SACRAMENTO MUNICIPAL UTILITY DISTRICT □ P. O. Box 15830, Sacramento CA 95852-1830, (916) 452-3211
AN ELECTRIC SYSTEM SERVING THE HEART OF CALIFORNIA

Docket No. 72-11
Rancho Seco Independent Spent Fuel Storage Installation
License No. SNM-2510

REQUEST FOR ASME CODE EXCEPTION

A TRANSNUCLEAR NONCONFORMANCE REPORT (NCR)

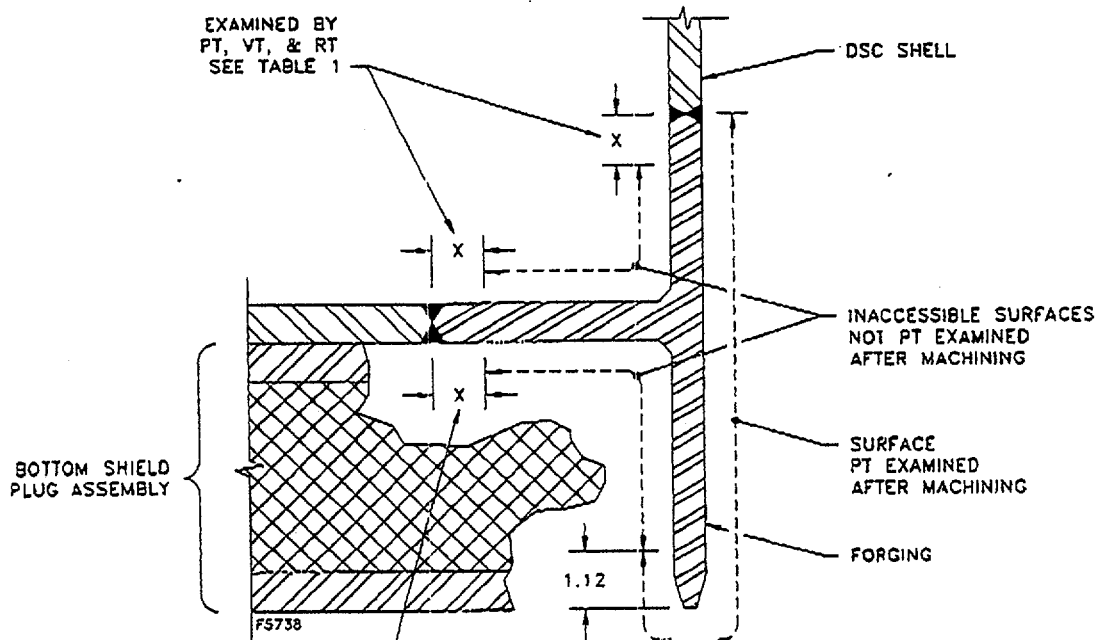
The bottom end forging is to be fabricated to Subsection NB in accordance with procurement drawing NUH-05-1032. While the material supplier examined the bottom forging material using PT and UT, additional machining of the forging (approximately 1/8 in. removed from all surfaces) was performed during the fabrication process. Subsequent to the additional machining, surface examination of some forging surfaces was not performed in accordance with ASME Paragraph NB-4121.3. Once this nonconformance was discovered, accessible areas of the forging were PT examined in accordance with NB-4121.3. Areas that were and were not PT examined after final machining are shown in the following figure.

TN Requirement: PT examination of the bottom end forging per NB-4121.3 following machining.

Nonconformance: Some areas were not PT examined after machining (See attached RANOR NCR).

Disposition: Use-as-is

Although a PT examination of some areas of the post-machined bottom forging was not performed in accordance with NB-4121.3, the existing configuration is deemed acceptable and is dispositioned "Use-as-is" for the following reasons:

ATTACHMENT TO NCR 02-101
Pg 2 of 2

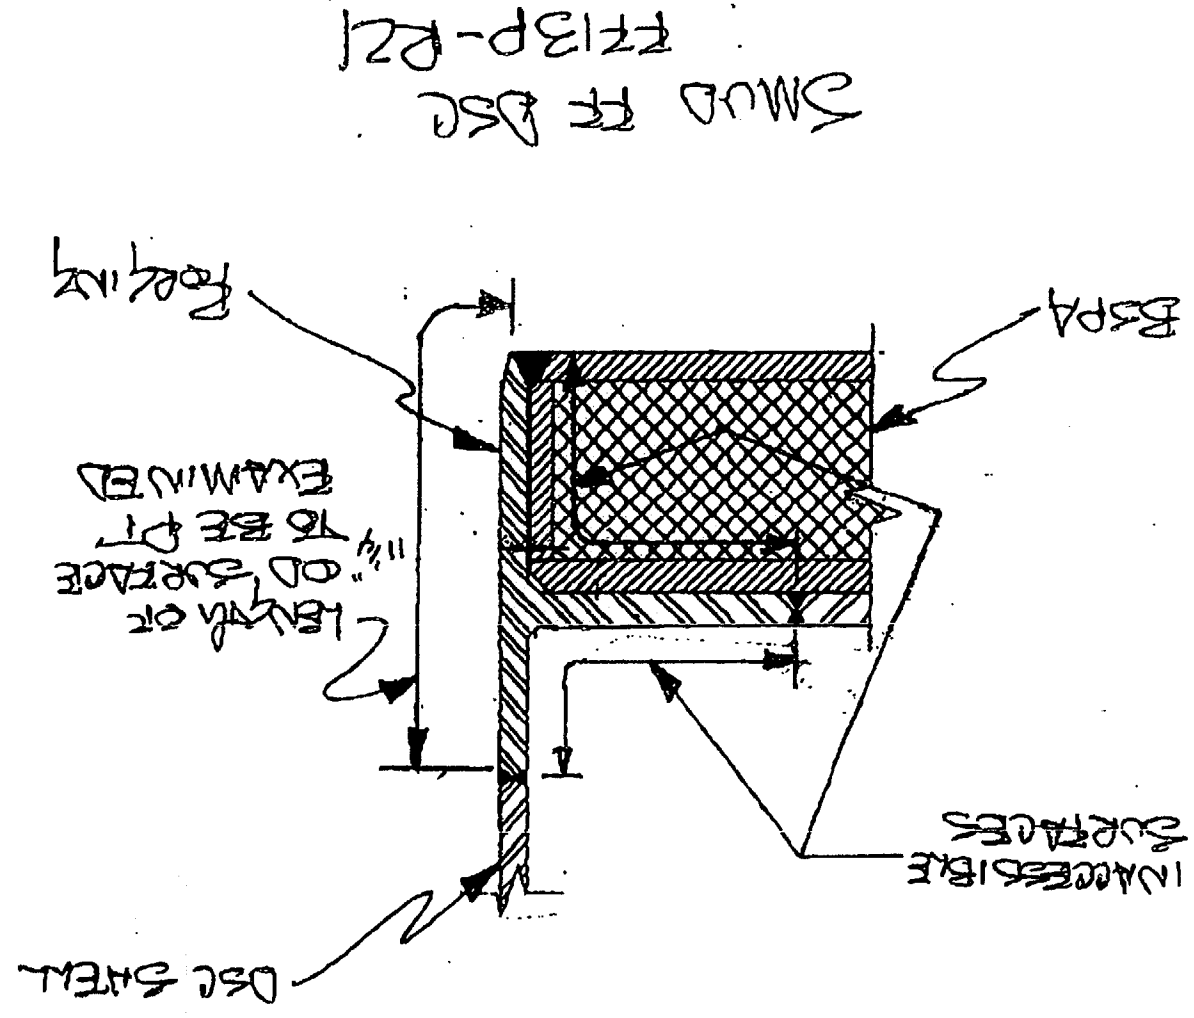
This NCR addresses the surface inspection requirements of NB4121.3, which were not satisfied for the bottom T-forging of the FF13P-R21 DSC. The T-forging is now installed in the DSC and both the basket and BSPA are welded in place.

This prevents access to the inside surfaces of the forging and no surface examination is possible. However the external (OD) surface of the forging is available for surface examination. Performance of this surface examination, and the successful results, will assist in justifying the "Use-As-Is" disposition for the inner surfaces.

RANOR is therefore directed to perform a surface examination of the OD section of the forging as shown in the attached figure. This inspection may be performed @ any time prior to cleaning and packaging.

This inspection shall use approved procedure, TNW/FF-PTE-2 and qualified personnel. The inspection shall be documented on an NDE form and that documentation shall be included as part of NCR 02-101 in the final data package.

Figure 1. Flaw Model used in Evaluation

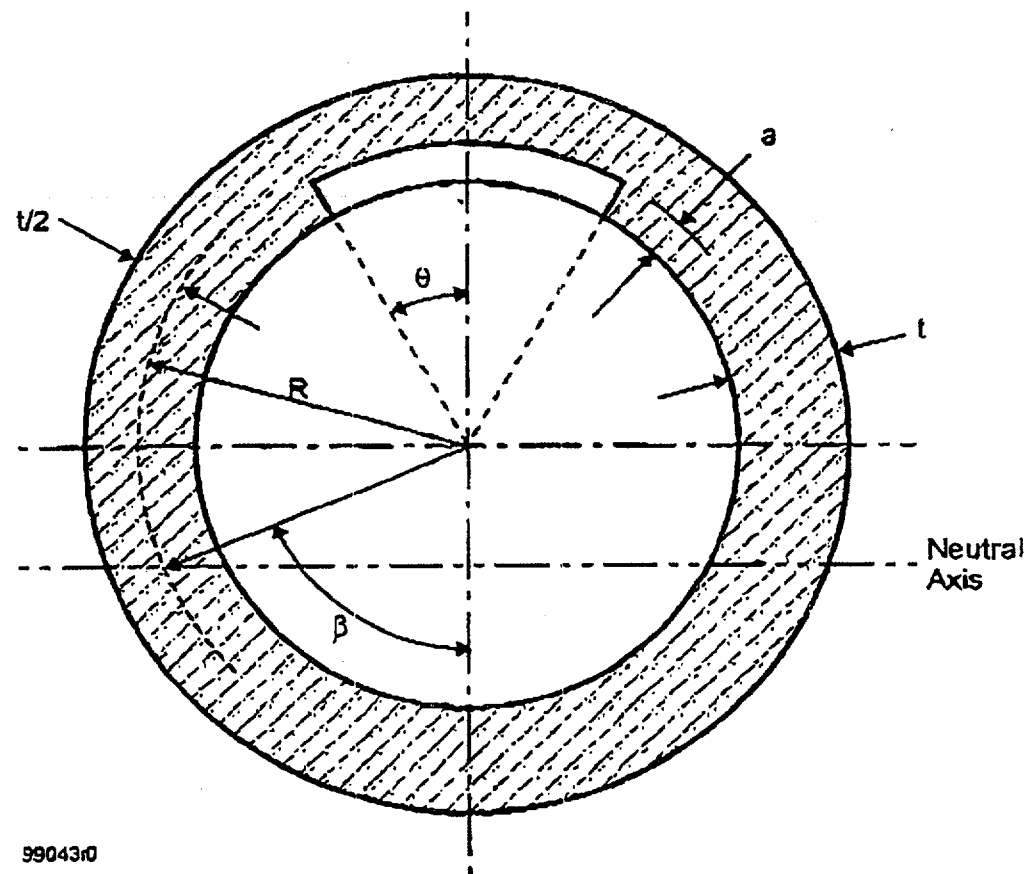
The flaw model considered for this evaluation is shown in Figure 1. It consists of part through-wall, part-circumference flaw in a cylinder. At the point of plastic collapse, the applied load has to be resisted by the un-cracked ligament in the section that is fully plastified. The classic net-section plastic collapse equations that form the basis for the ASME Code Section XI flaw evaluation procedures [1] can be used to determine the allowable flaw size in the forging. These equations are expressed as:

Figure 1 provides definition of the geometric terms used in the above equations.
